## METROPOLITAN DEVELOPMENT COMMISSION

April 2, 2025

<b>Case Number:</b>	2025-ZON-005
<b>Property Address:</b>	8830 and 8850 Rockville Road (Approximate Addresses)
<b>Location:</b>	Wayne Township, Council District #17
<b>Petitioner:</b>	HKZ Properties, LLC, by Ron Sears
<b>Current Zoning:</b>	D-A
<b>Request:</b>	Rezoning of 1.527 acres from the D-A and D-3 districts to the C-3 district to provide for commercial uses.
<b>Current Land Use:</b>	Residential
<b>Staff Recommendations:</b>	<b>Denial</b>
<b>Staff Reviewer:</b>	Desire Irakoze, Principal Planner II

**PRELIMINARY SITE PLAN**

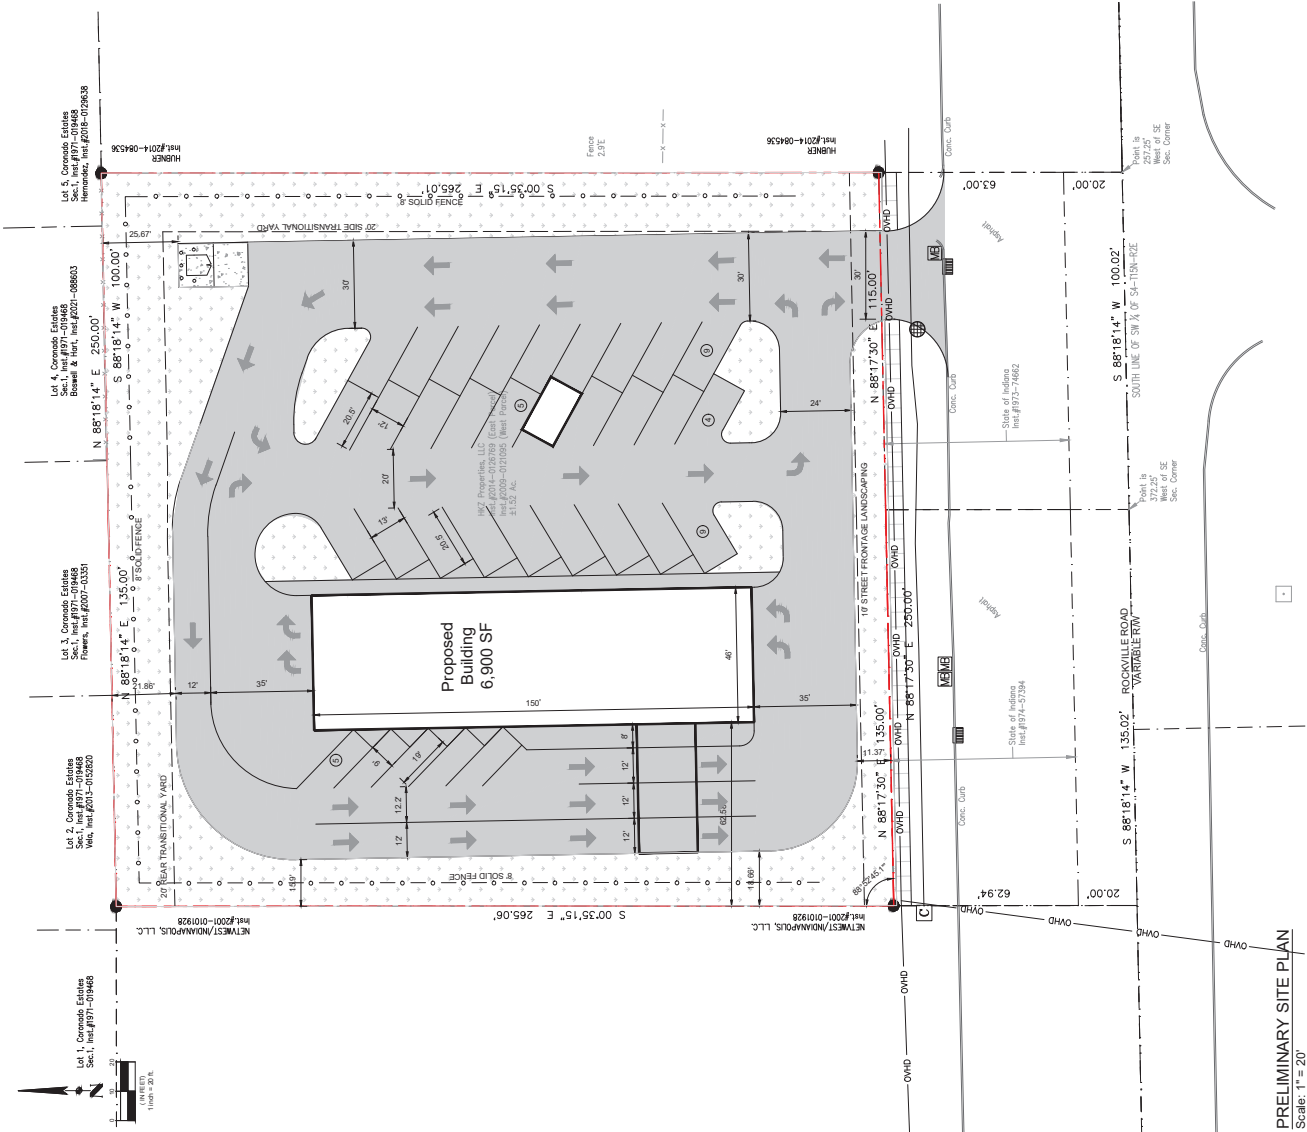
1. **Uses Restricts: Per Sec. 744-210 Table 743-1,** Automobile and Light Vehicle Wash is not permitted in the C-3 Zoning District – However, the submitted site plan dated (11/02/2021) is for a Carwash.

3. **Pedestrian Access: Per Sec. 744-301-F.1,** walkways must connect the sidewalk system to public pedestrian entrances. The submitted site plan does not include such a walkway.

4. **Proximity to Protected Districts:** Per Sec. 743-305. D.3, the proposed use must not be located within 100 feet of a protected district. The property abuts a protected district.

5. **Driveway Length Requirement:** Per Sec. 743-305. D.4, exit drives must be at least 100 feet in length from the car wash exit to the street. The site plan shows only 67 feet.

6. **Drive-Through Circulation:** Per Sec. 774-406. C.5, sites in the Metro Context area with stacking spaces must include a bypass aisle or other circulation design. Staff is concerned that the site cannot adequately accommodate a drive-through use.

7. **Drive-Through Location Restrictions:** Per Sec. 744-406. C.7, drive-through service units must not be located on the side or rear of a building abutting a protected district unless they meet landscaping and screening requirements. The site plan does not demonstrate compliance.

8. **Fence Height Violation:** Per Sec. 744-510.B, Table 744-510-2, the maximum permitted fence height in the rear and side yards of a C-3 district is 6 feet. The site plan proposes an 8-foot fence in these areas.
